Product Change Notification / GBNG-15STBN649

CCB 6193 Final Notice: Qualification of MTAI as an additional assembly site for selected ATTINY13A device family available in 8L SOIC (.150in) package with MSL 1 classification.

CCB 6193
Pre and Post Change Summary
PCN #: GBNG-15STBN649

Lead Frame Comparison

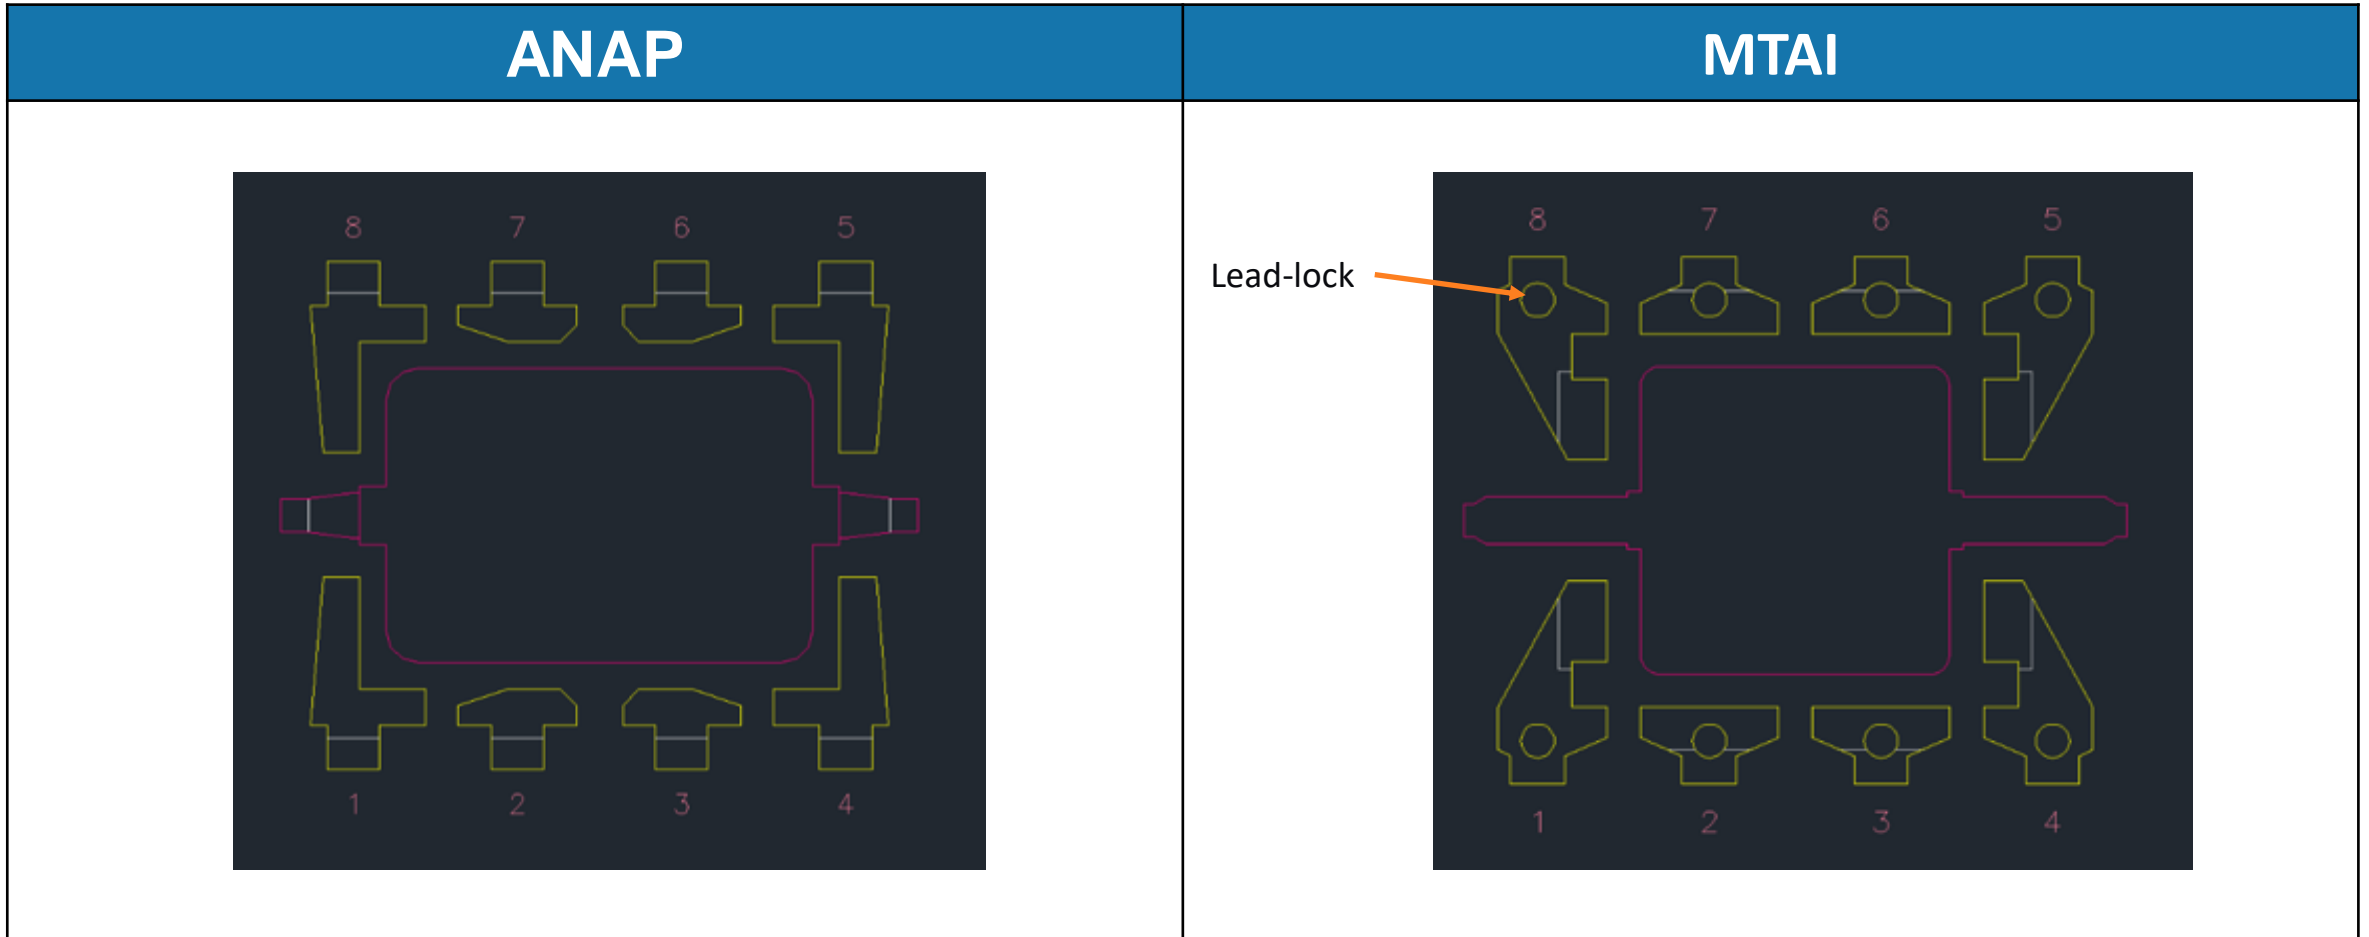
Note: The lead lock hole fills with mold compound during the assembly process and provides improved protection against moisture penetration around the interface edges between pins and mold compound.
